Land at Snow Capel, Winnycroft Lane, Matson
Planning reference: 22/00519/FUL

Ecology Addendum

Snow Capel, Matson, Gloucester LVIA Addendum & Rebuttal

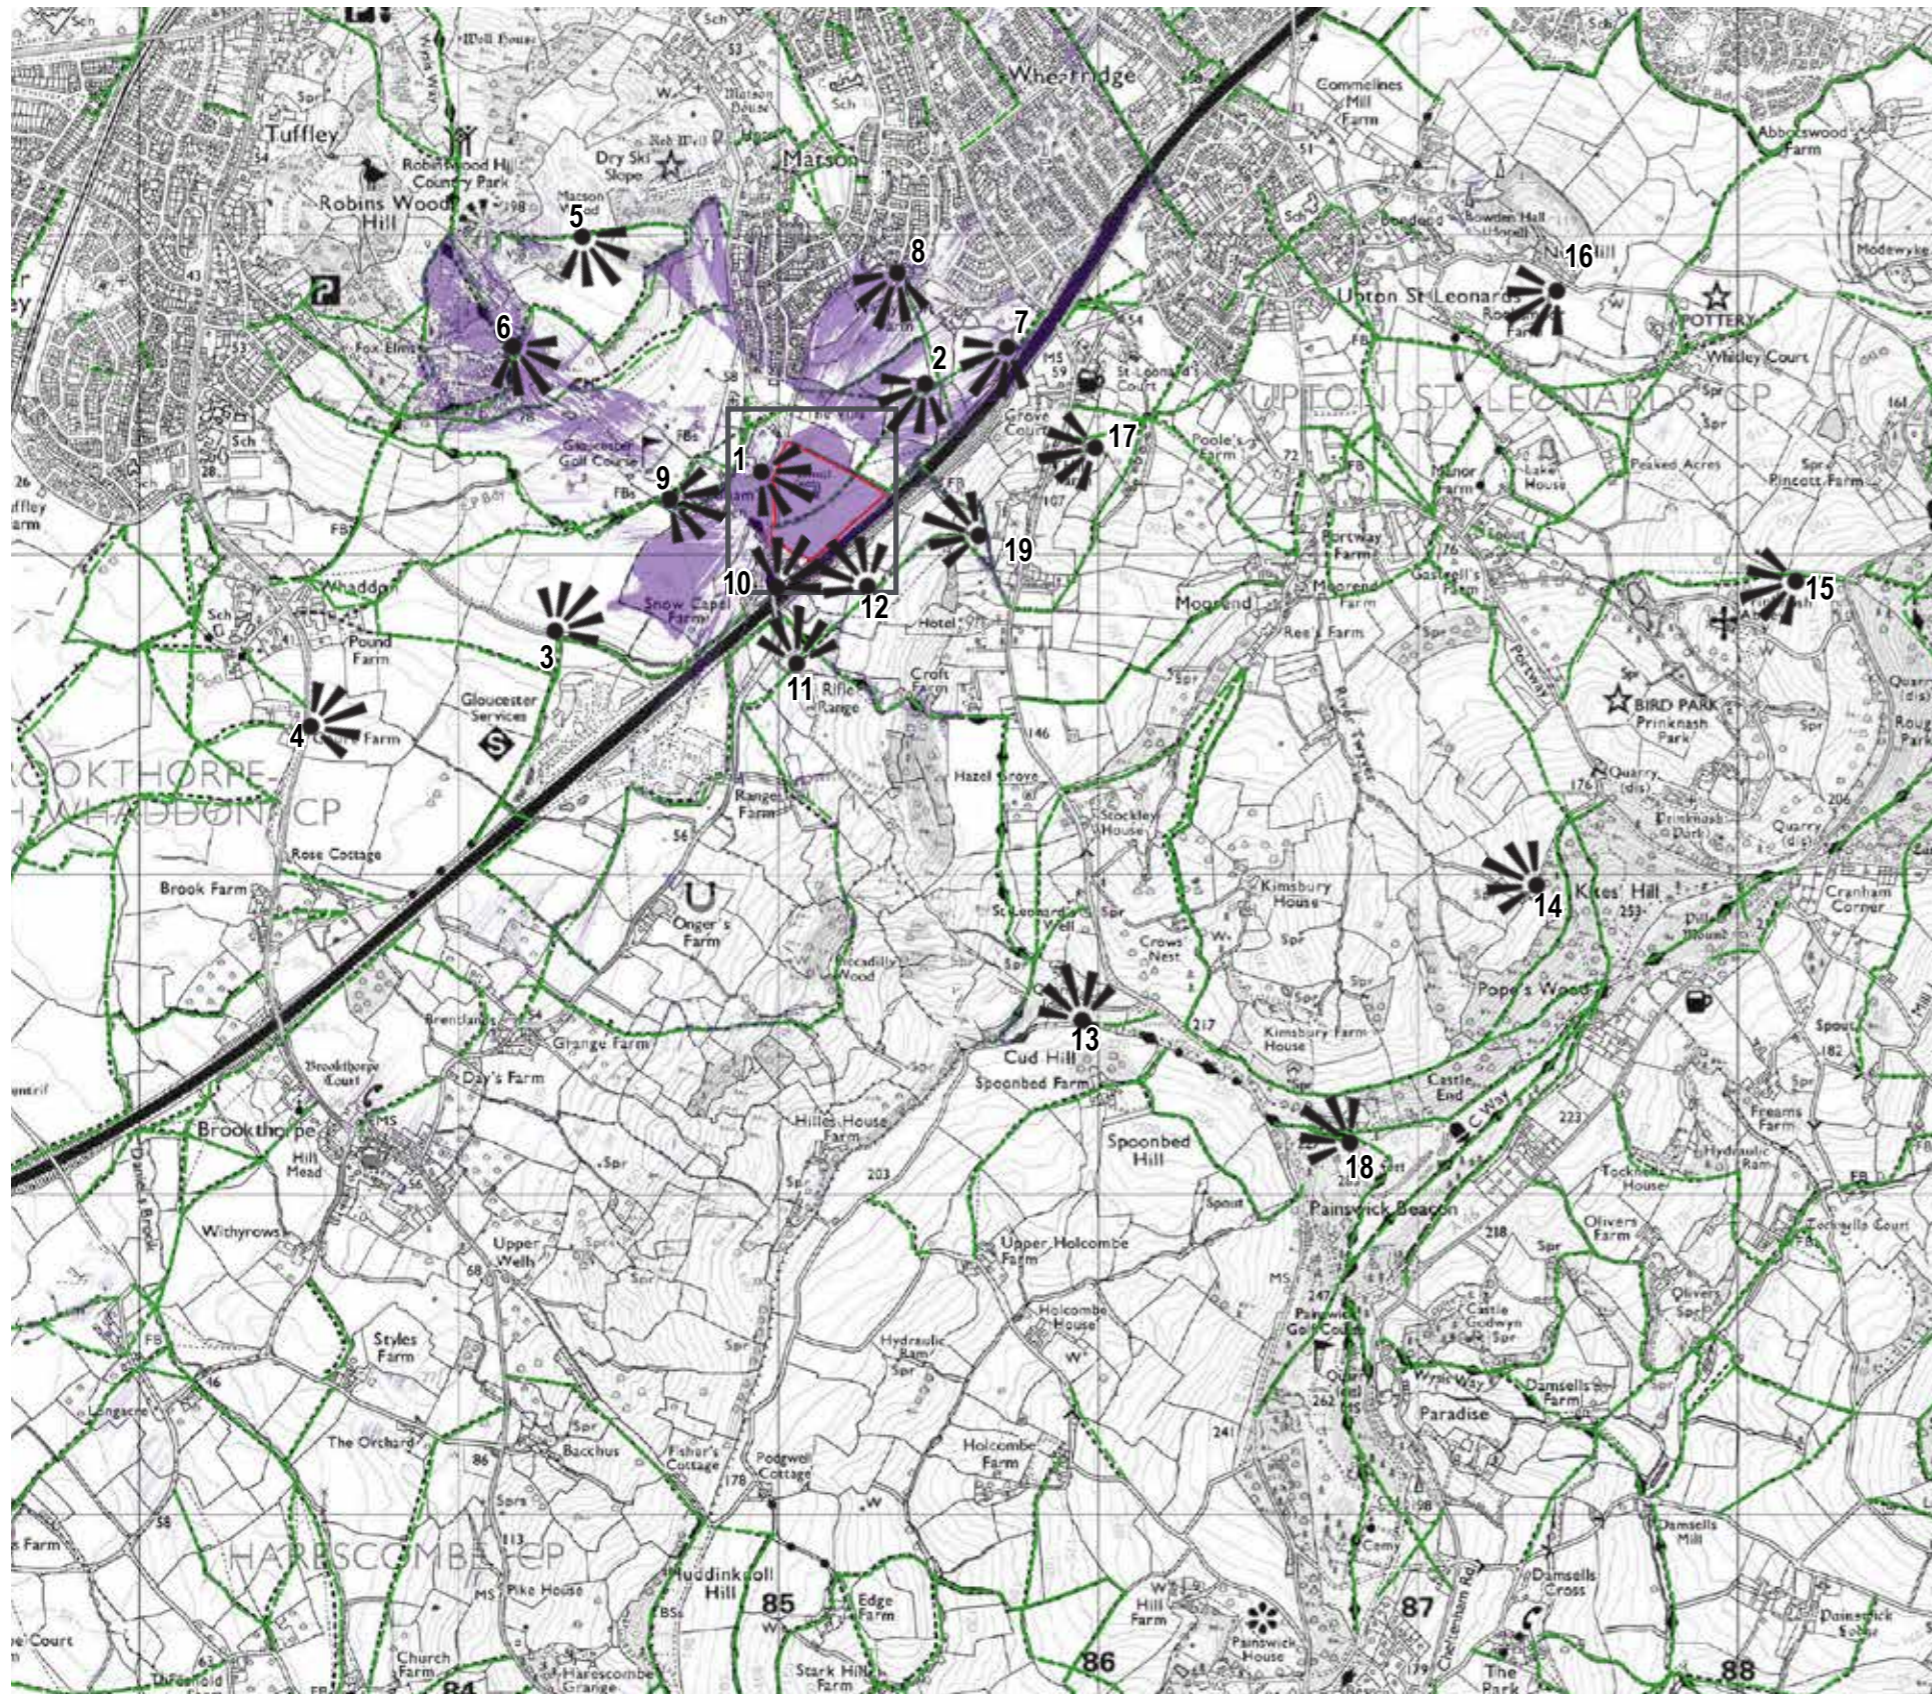
- 5.2.42 The LPA Officer states 'I strongly disagree with the conclusion that 15 years after development the magnitude of change from viewpoint 6 would be low

negative and the significance would be moderate adverse. The development would cause a break in the almost continuous rural corridor currently apparent in views between Robinswood Hill and the AONB and the adverse effect on views would be marked.'

- 5.2.43 Response: The LVIA Viewpoint 6 **does** provide detailed commentary on the viewpoint. The comments from the LPA Officer seem to be conflating many elements and does not clarify perceived issues, merely confuses.

Figure 10: Visual Analysis and Locations of Representative Views.
 Source: Ordnance Survey Crown Copyright 2022. All rights reserved. License Number 100022432

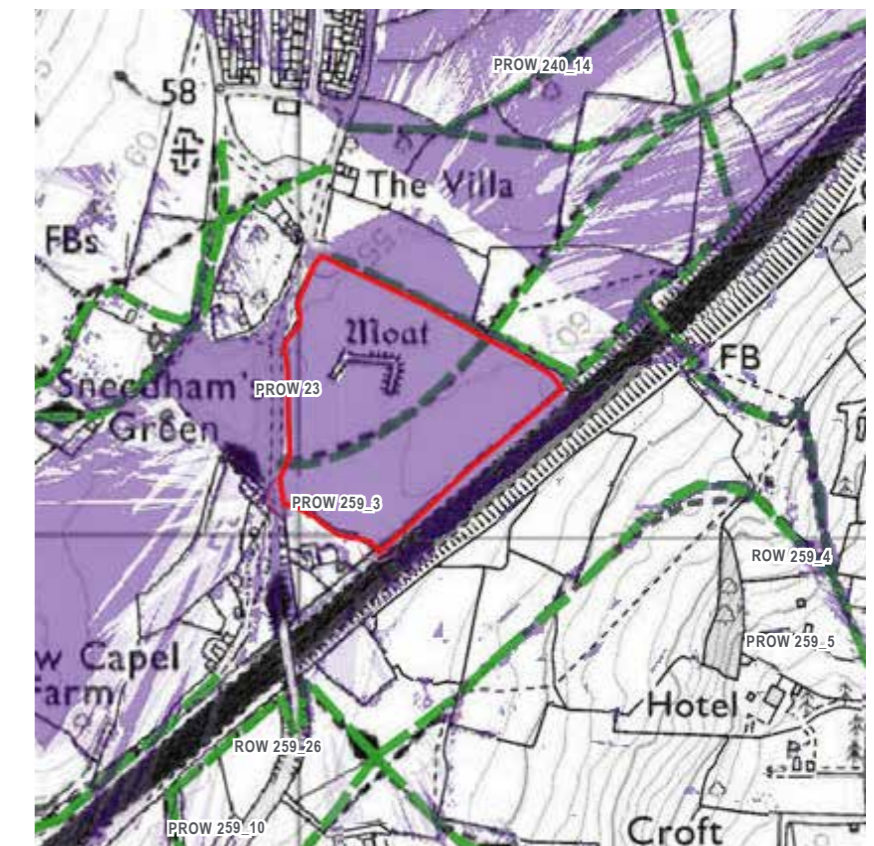
- 5.3.1 LPA Landscape Officer Comments: The LPA Officer states '*The summary of visual effects (p.46) appears to imply that visual impact can be quantified by adding up how many views had no significance of effect in 15 years and then comparing the total with those that did. Of the 18 viewpoints selected, 15 did not have any view of the site and these, as might be expected had no significance of effect. This is not a valid approach as any number of viewpoints from which the site could also not be seen could have been selected. The selection of viewpoints in this LVIA is clearly flawed, as a number of the most important views of the site were not included or properly assessed. "Of the eight viewpoints from within the AONB, none experience any change in view" (paragraph 6.5.7). The good news from the 8 viewpoints that couldn't see the site is clearly eclipsed by the bad news from the one that was not selected that has a very clear view of the site.'*

- 5.3.2 The LPA Officer continues '*Views from the AONB, from Robinswood Hill and from Sneedhams Green have not been properly considered and the likely adverse effects have certainly not been mitigated in any consequential way. In the case of the AONB this is because the LVIA didn't include relevant and clear views from the AONB.'*

VIEWPOINT 19

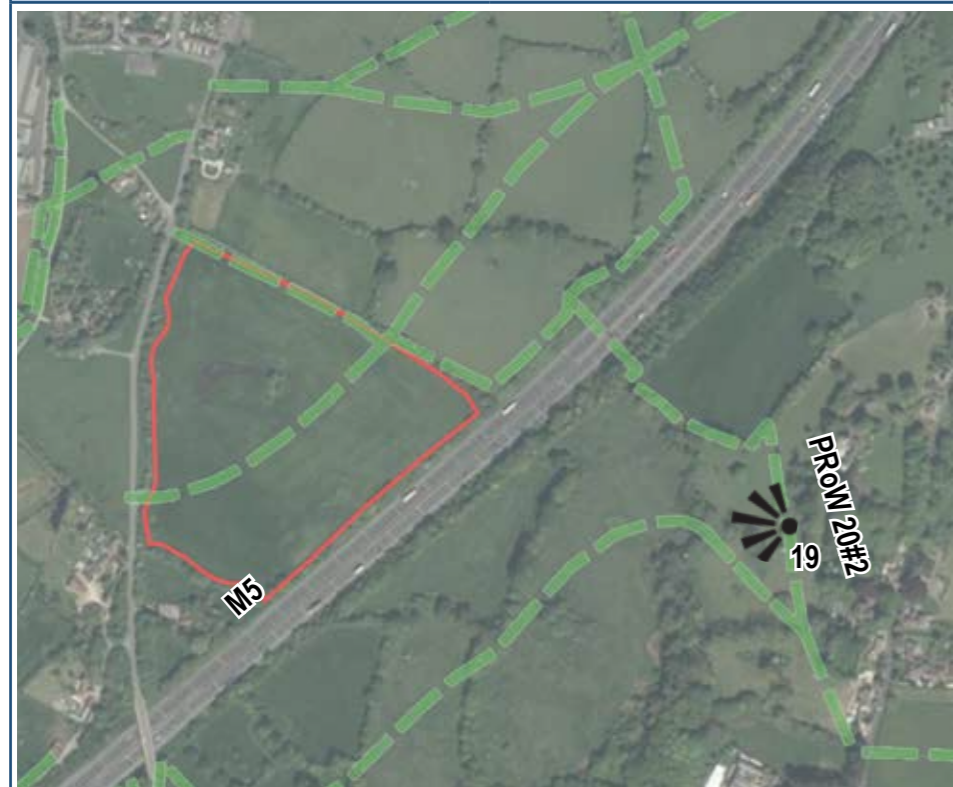
3.2.9 It is acknowledged that one clear viewing point is afforded from PRoW UPTON ST LEONARDS FOOTPATH 25#2, and that this was unfortunately missed. However, as clearly described and set out within the LVIA methodology at 2.4.13, the viewpoints and supporting photographs do not provide continuous coverage of all locations within the vicinity, but provide a reasonable sample of representative, specific and illustrative views. As is best practice and set out within the Guidelines for Landscape and Visual Impact Assessment 3rd Edition, (Landscape Institute and Institute of Environmental Management and Assessment).
